U S NAVY RESPONSE TO SOUTH CAROLINA DEPARTMENT OF HEALTH AND
ENVIRONMENTAL CONTROL COMMENTS TO RCRA FACILITY INVESTIGATION REPORT
ADDENDUM SOLID WASTE MANAGEMENT UNIT 163 (SWMU 163) ZONE K WITH
TRANSMITTAL CNC CHARLESTON SC
9/30/2004
CH2M HILL

Re: CH2M-Jones' Responses to Comments by SCDHEC regarding the *RFI Report Addendum II, SWMU 163, Zone K, Revision 0*, originally submitted on June 17, 2004

This document presents CH2M-Jones' responses to specific comments made by the South Carolina Department of Health and Environmental Control (SCDHEC) based on its review of the RCRA Facility Investigation (RFI) Report Addendum II for SWMU 163, Zone K, Revision 0 (CH2M-Jones, June 2004).

PROJECT NUMBER 158814.ZK.EX.07	WELL NUMBER 166GW042D	SHEET 1 OF 1
-----------------------------------	--------------------------	--------------

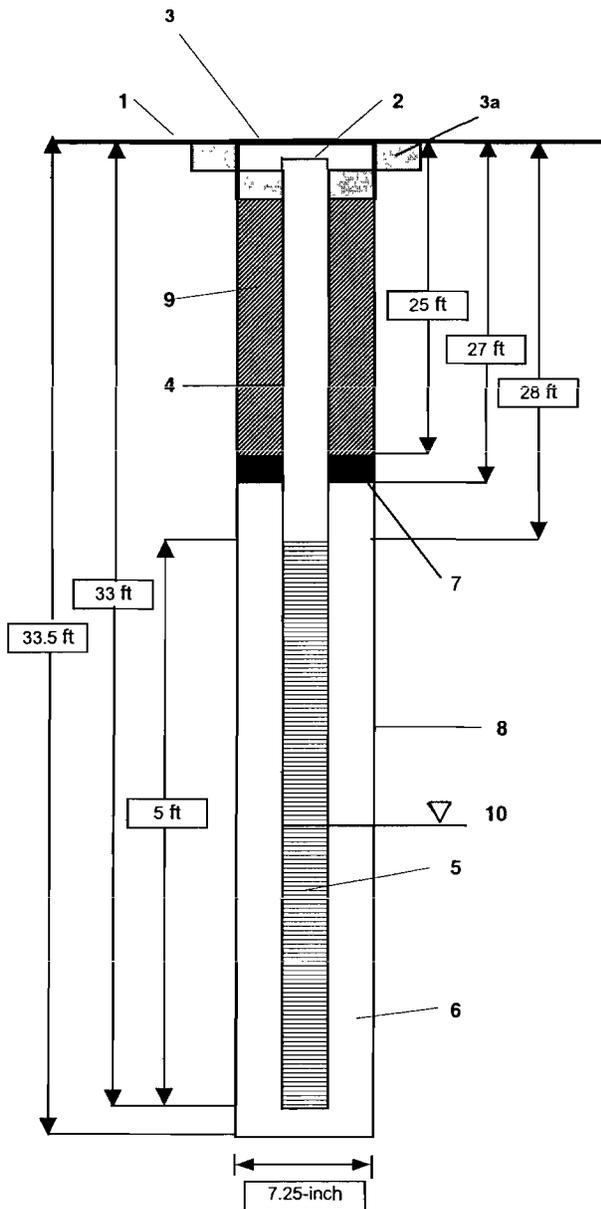
1. Well Construction Diagrams:

- a) Type/slot size of screen: The term "dia." is inaccurate, and should be removed.

- b) The use of bentonite pellets is preferred over the specified bentonite chips. The chips do not hydrate as quickly or completely as the pellets. Regardless of the type of bentonite used in the future, the hydration time for the bentonite should be specified in order to show adequate hydration of the seal prior to grout emplacement.

- c) The water table should be presented graphically on these diagrams.

The Navy agrees with SCDHEC and has revised the well construction diagrams by deleting the "dia." text. The revised well construction diagrams for monitoring wells K166GW42D and K166GW43D are attached to these responses to comments (see Attachment 2).

The Navy used 3/8-inch diameter bentonite pellets to seal each well (K166GW42D and K166GW43D). This reference is identified in Footnote 7 in the attached well construction diagrams (see Attachment 2).

The Navy agrees with SCDHEC and has added the groundwater elevation in Footnote 10 to the attached well construction diagrams (see Attachment 2).
